STAFF RECOMMENDATION
513 Fatherland Street
February 20, 2013

Application: New construction -primary structure
District: Edgefield Historic Preservation Zoning Overlay
Council District: 06
Map and Parcel Number: 08215020600
Applicant: Peggy Newman
Project Lead: Melissa Baldock, melissa.baldock@nashville.gov

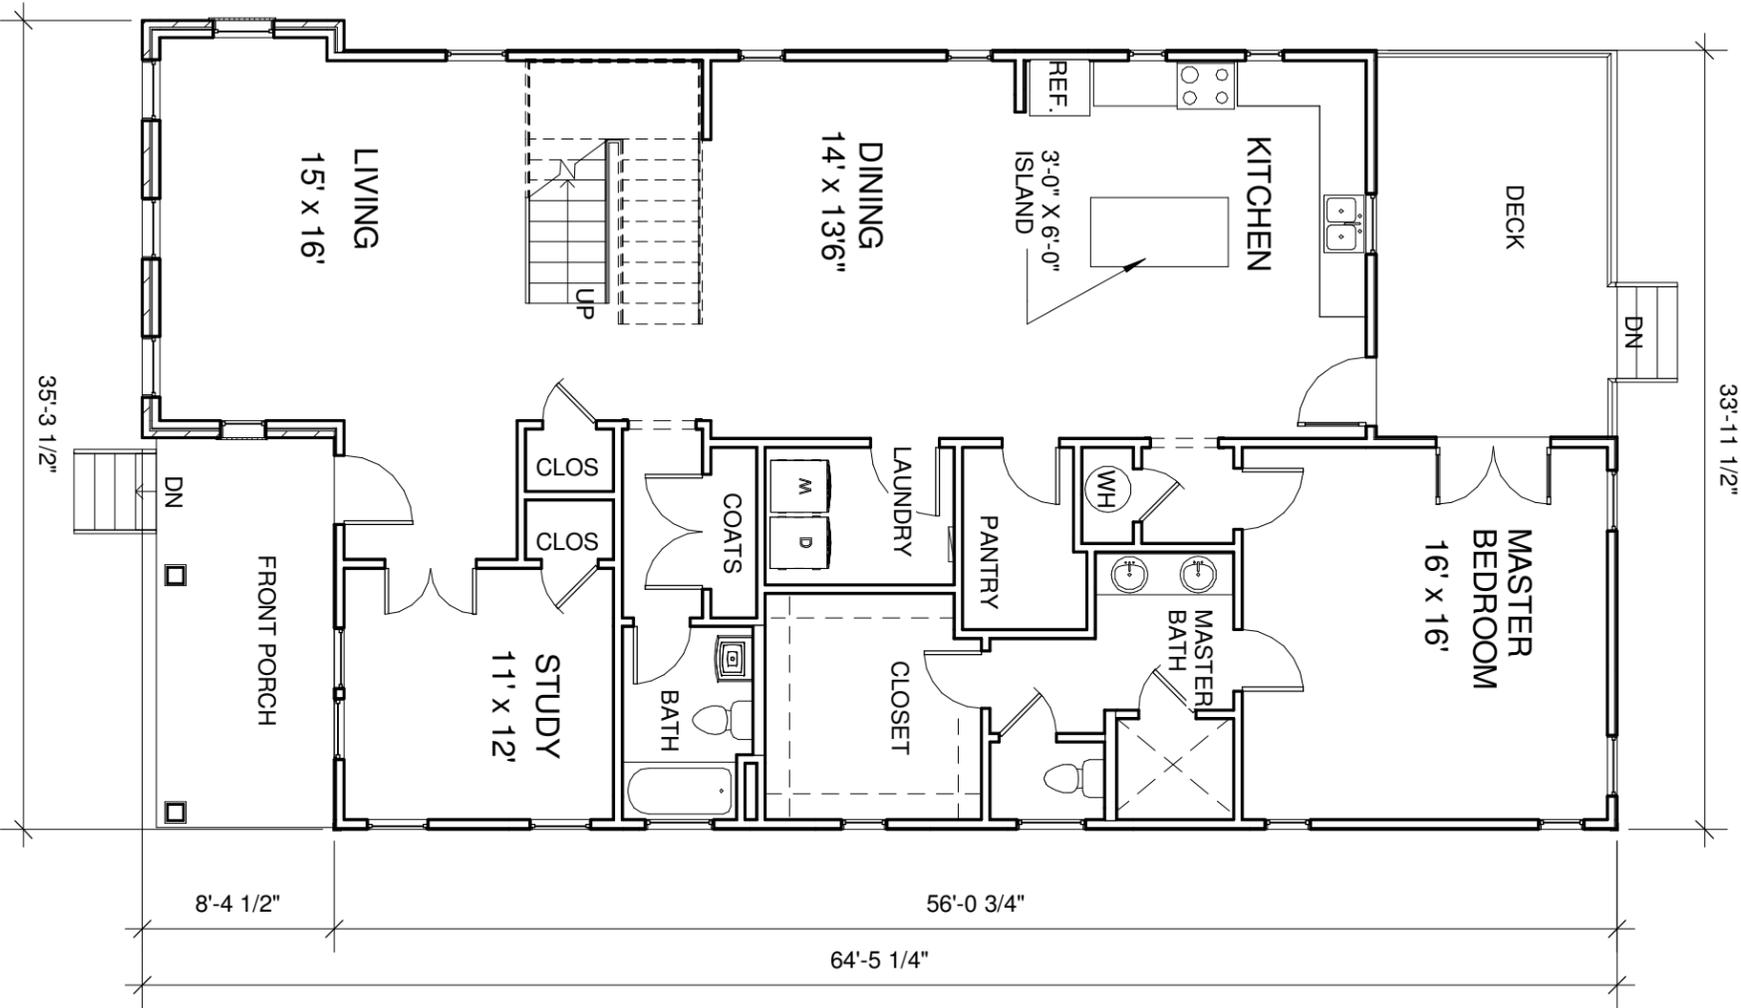
Utilities: The location of the HVAC system is unknown at this time. Staff recommends that it be located at the rear of the home or on the side, beyond the mid-point of the house.

Fences: No fences were called out on the site plan, and staff reminds the applicant that in the Edgefield Historic Zoning Overlay, all fences must receive a preservation permit.

Permanent Built Landscape Features & Public Space: The applicant is proposing a central walkway leading from the sidewalk to the front porch, which is appropriate. Another walkway will be installed in the rear, leading from the deck to a new parking pad. Staff finds these landscape features to be appropriate, and asks to review the walkway and parking pad material prior to installation. No other lighting, walkways, walls, or other appurtenances were indicated on the drawings, and staff asks to review and approve any new appurtenance. With the approval of the material, staff finds the walkways and parking pad to meet Sections IV.B.2. and IV.B.4. of the *Edgefield Historic Zoning District: Handbook and Design Guidelines*.
